# Elec-Trak<sup>®</sup>

## PRODUCT SERVICE BULLETIN NO. OPSB 74-1

February 22, 1974

### E20 TROUBLE-SHOOTING (MODEL AA-DA)

Figure 1

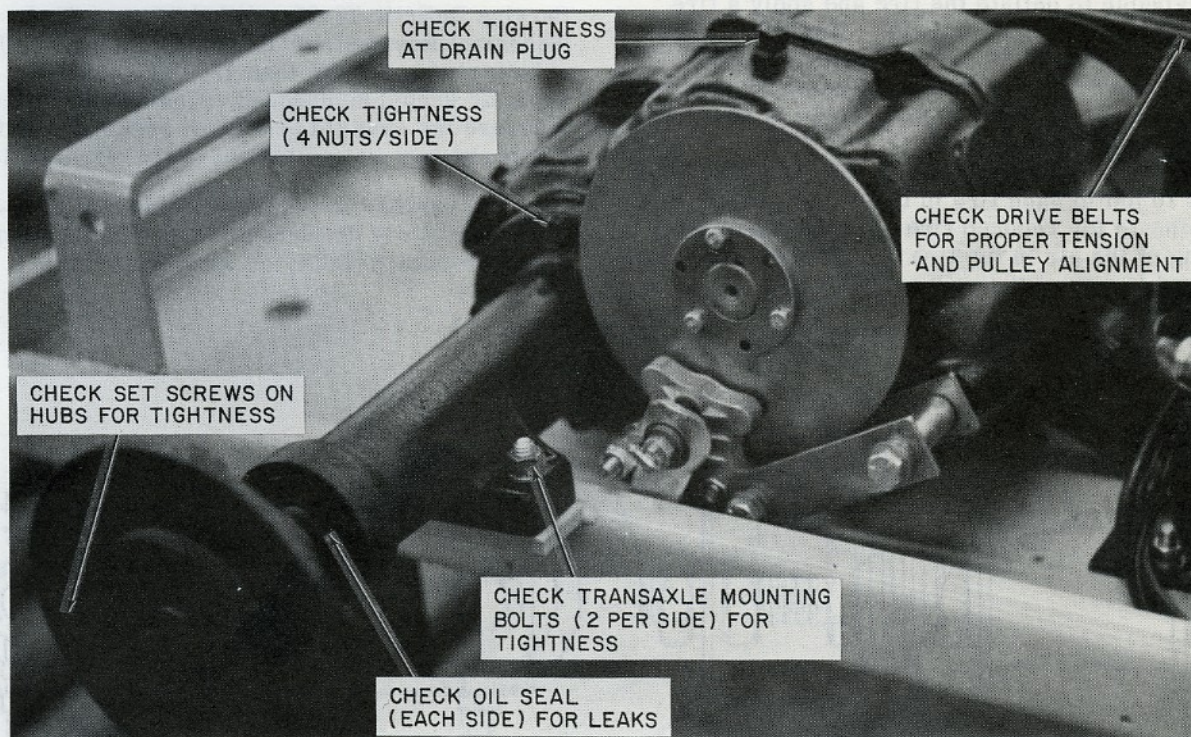
Product Service Bulletin No. 72-21, dated June 22, 1972, explains a procedure for location and correction of poor connections at Card #4. Cleaning of the copper contact pads on the Card #4 is recommended in that bulletin. We have found that replacing the Card #4 with one having solder tinning on the contact pads is a more permanent solution to the contact problem.
